Access Compliance Report

Public Rights-of-Way

(Pedestrian Signals)

Intersection ID: N/A	Main Street:	Cross Street: N/A	Location: N/A
ADA ID: 68B519C45F79	Signal Type: Two Push Buttons-Non APS	Overall Compliance: No	Severity Score: BTN 1:N/A BTN 2: N/A No BTN: N/A
Codes/Mitigation Info/Possible Solution		Field Measurements/Component Compliance

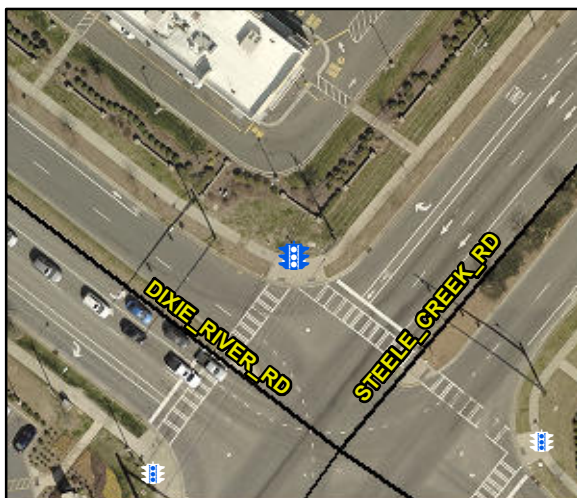
PROW/ADA: TMUTCD 4e.08, R406.2

Yes	B 1 Clear Xing Direction?	ClearlyMarked	Yes	B 2 Clear Xing Direction?	ClearlyMarked
	B 1 Crossing Direction	To SW		B 2 Crossing Direction	To SE
Yes	B 1 DistanceTo XWalk (in)	0.0	Yes	B 2 DistanceTo XWalk (in)	40.0
No	B 1 DistanceTo Curb (in)	176.0	No	B 2 DistanceTo Curb (in)	177.0
Yes	B 1 Diameter (in)	2.0	Yes	B 2 Diameter (in)	2.0

Possible Solutions: Replace Signal Push Button With APS Button on New Post. Remove & Relocate Sign.
